## PROJECT COMMITMENTS

Proposed US 701 and NC 87 Bypass Interchange,  
Bladen County  
Federal-Aid Project NHF-87(15)  
WBS Element 40226.1.1  
**TIP Project R-4903**

INTERSECTION OF NC 87 AND US 701  
BLADEN COUNTY  
TIP PROJECT R-4903

FIGURE 1

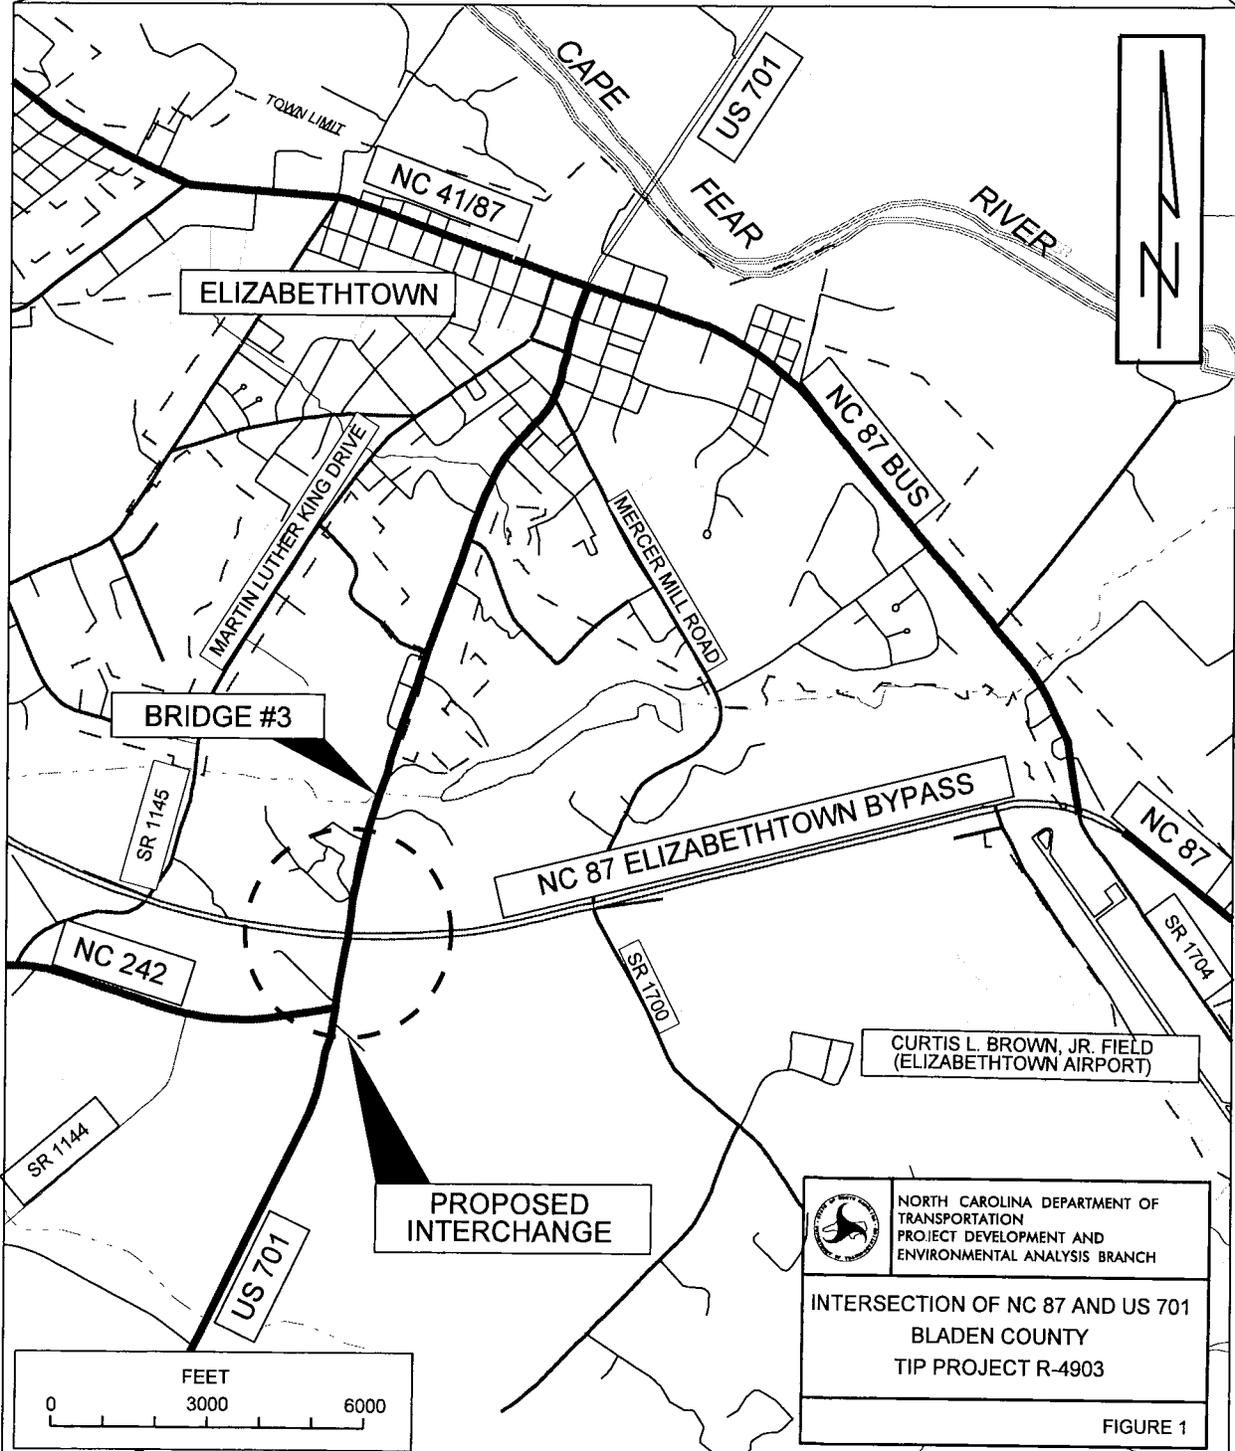
The alignment of the proposed ramp from northbound NC 87 onto US 701 has been changed in order to reduce the amount of right of way required from the former Bladen County Landfill. This design change will reduce impacts to the landfill and will reduce stream impacts by approximately 100 feet.

Following completion of the CE, a landowner notified NCDOT Roadway Design of gravesites located in the northeast quadrant of the proposed interchange. Surveys have confirmed there are approximately 26 graves within the proposed right of way for the project. Due to the location of the graves, the project alignment cannot be shifted to avoid them. These graves will be relocated in accordance with GS 65-13.
